South Dayton Dump OU 1 Hot Spot Issues
Ohio EPA
April 17, 2012

Vadose Zone VOC Hot Spots

Ottoson Solvents Drums

Photograph taken by: Dale Farmer, Ohio EPA Emergency Response, Southwest District
Date: May 17, 2000

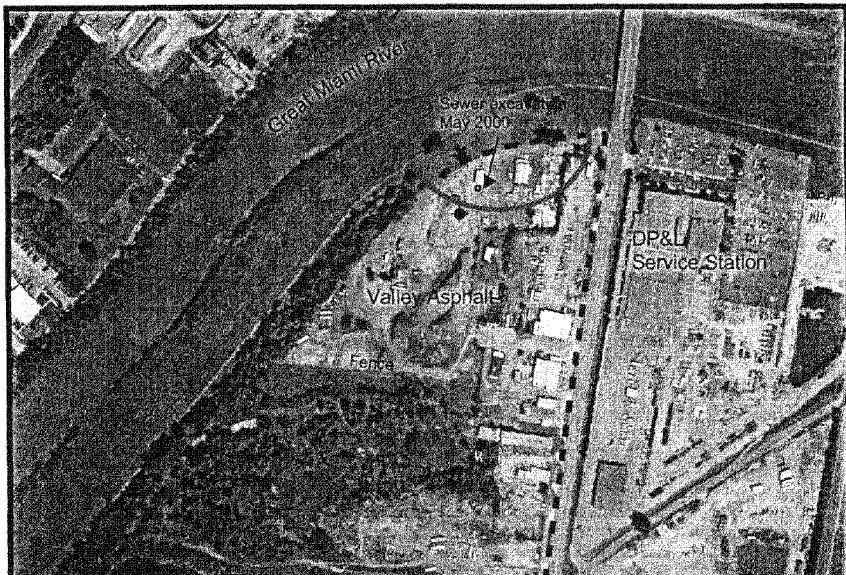
Ottoson Solvents was a drum recycler that began operation in the late 1950s on approximately two acres of what is now part of the Valley Asphalt property. Ottoson Solvents bought used drums from companies and repainted, refurbished, and resold the drums. Reportedly, if the drums contained residuals, the residuals would be emptied into another drum and, when that drum was full, it would be buried.¹ The drums were first encountered in 2000 during excavation for a sewer line at Valley Asphalt. Five drums were excavated from the shallow sewer trench before the excavation was halted. A number of other drums visible in the sewer excavation were left in place (see Attachment 1).

The drums contain liquids. Pictures of the 2000 sewer line excavation show a decapitated drum containing liquids in the path of the excavation (see attachment 5). The drum from the 2008 test trench contained 26% liquid based on laboratory analysis.

Attachment 3
From Figure 2.2,
April 2010 RI Report

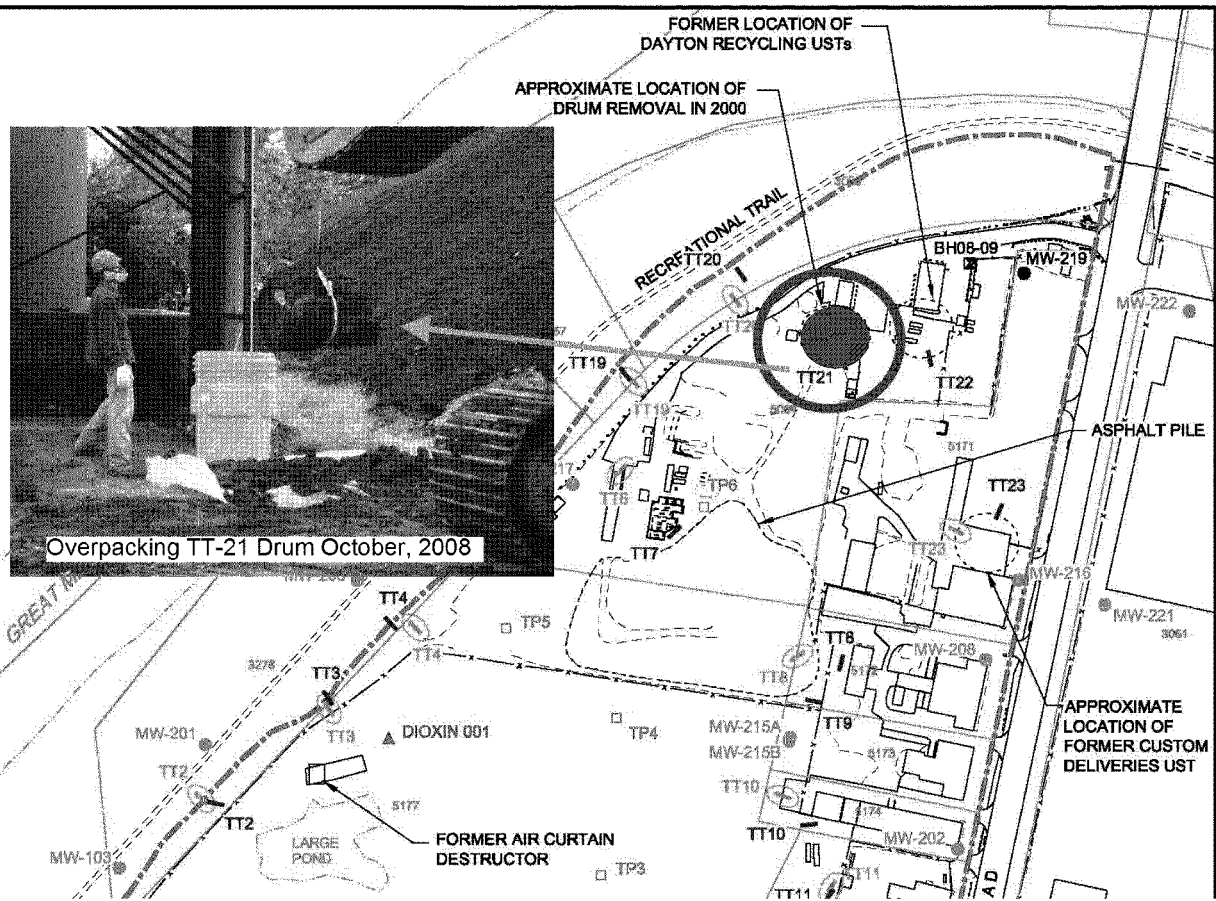
Both the presence and location of the Ottoson Solvents drums were known at the time the Administrative Settlement Agreement and Order on Consent (ASAO) for Remedial Investigation/ Feasibility Study (RI/FS) of the Site was negotiated. Specific language requiring investigation and evaluation of hot spots was incorporated throughout ASAO as a result, and their location, identified as "Sewer Excavation May 2000," was depicted on Figure 1 of the ASAO (see Attachment 2). The location of the drums was confirmed during the limited RI when test trench TT-21 was excavated at what was assumed to be the perimeter of the drum disposal area (see Attachment 3). The test trench confirmed the presence of drummed waste at the location identified in the ASAO (see Attachment 3).

The Ottoson Solvent drums are located in the northern end of the existing business area being considered for the specialty asphalt (Matcon) cap. As can be seen from Attachments 2 and 3, the location of the drums is near the GMR, in an area of shallow groundwater table fluctuations and flow reversal during high water events. As outlined above, it is evident that the drums contain a variety of principal threat wastes, are near-surface and readily accessible, and based on all available information, appear to be limited to the northwestern edge of the two-acre area leased by Ottoson Solvents. Unlike the vadose zone VOC hot spots, there is no hope that the wastes in the drums will eventually be removed by an active landfill gas extraction system.

Given the above, the Ottoson Solvent drums should be removed from the Site. Their location is known, they are readily accessible, and they contain wastes which by their very nature cannot be reliably contained under the most favorable conditions. Further evaluation of this hot spot prior to issuance of the OU 1 Proposed Plan is warranted so that appropriate response actions can be incorporated into the plan and, following public comment, into the ROD.
